# Statement of Response to Council Opinion

Kinsale Road LRD

Prepared in June 2025 on behalf of  
**BML Duffy Property Group Limited**

**Figure 2 Bike Shed Details.**

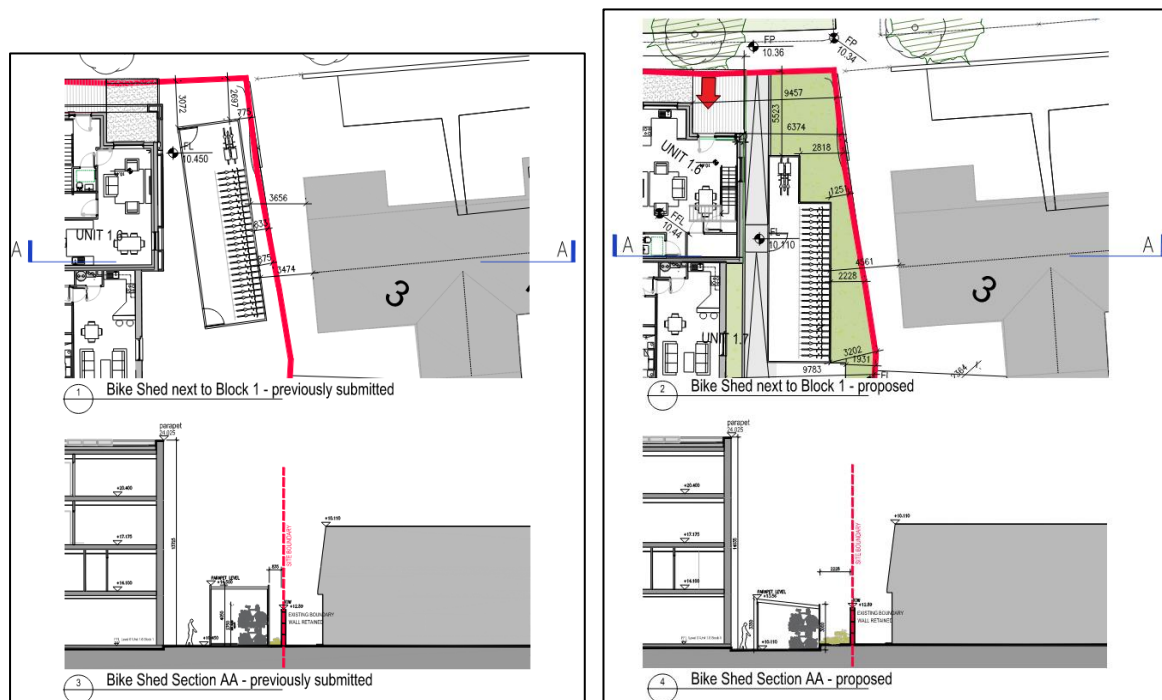
*The applicant is requested reconsider the configuration of the bike shed on the northeast corner of the site (Block 1), there are concerns regarding overbearance and overshadowing of the neighbouring dwelling to the northeast given its height and proximity to the boundary. In addition, the application is requested to provide a section showing the relation between Block 1 and the neighbouring dwelling to the northeast.*

- 2.42 The location and configuration of the bike shed adjacent to Block 1 on the Pearse Road has been revised to address the comments of the Planning Authority.

- 2.43 The revised proposal shows the bike shed with a floor level 220mm lower than Pearse Road, accessed via a ramp, at a level of 10.11OD. The plan has been adjusted to set the bike store back from the boundary as much as possible, 2800mm from the boundary as seen from Pearse Road and 1250mm at the closest point.

- 2.45 The relationship between the bike shed and the neighbouring dwelling is shown in Drawing No. KRC-BKD-ZZ-ZZ-DR-A-1210\_A which illustrates the previously submitted and current proposal for bike/bin stores at Pearse Road.

- 2.46 Please also refer to drawing KRC-BKD-ZZ-ZZ-DR-A-1200\_G for details of revised bikes and bin stores.

**Figure 4 Potential Signage Locations Block 4.**

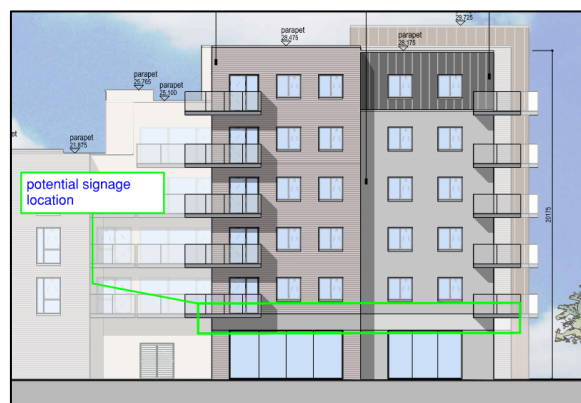
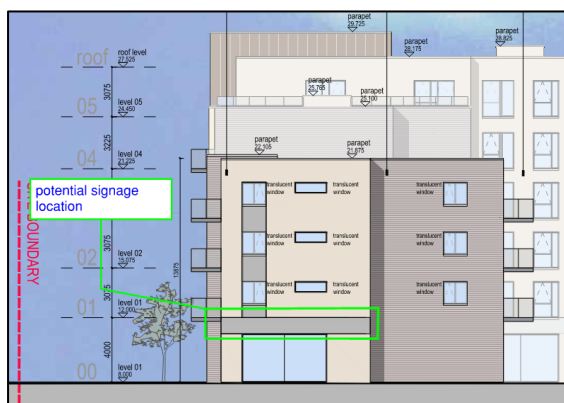
*The applicant is requested to provide details of the proposed signage for all commercial elements of the scheme.*

- 2.76 No end users have been identified in respect of the end users for all commercial elements of the proposed development. As a result, the requested details in relation to the signage for these areas cannot be provided.
- 2.77 Potential signage areas have been identified at ground floor level in respect of the proposed retail units, as indicated below. It is proposed that the details of all signs are to be submitted to the Planning Authority by way of compliance for agreement prior to the occupation of these units.
- 2.78 The signage areas are illustrated below and in Drawing No. KRC-BKD-04-ZZ-DR-A-2000\_F prepared by BKD Architects.
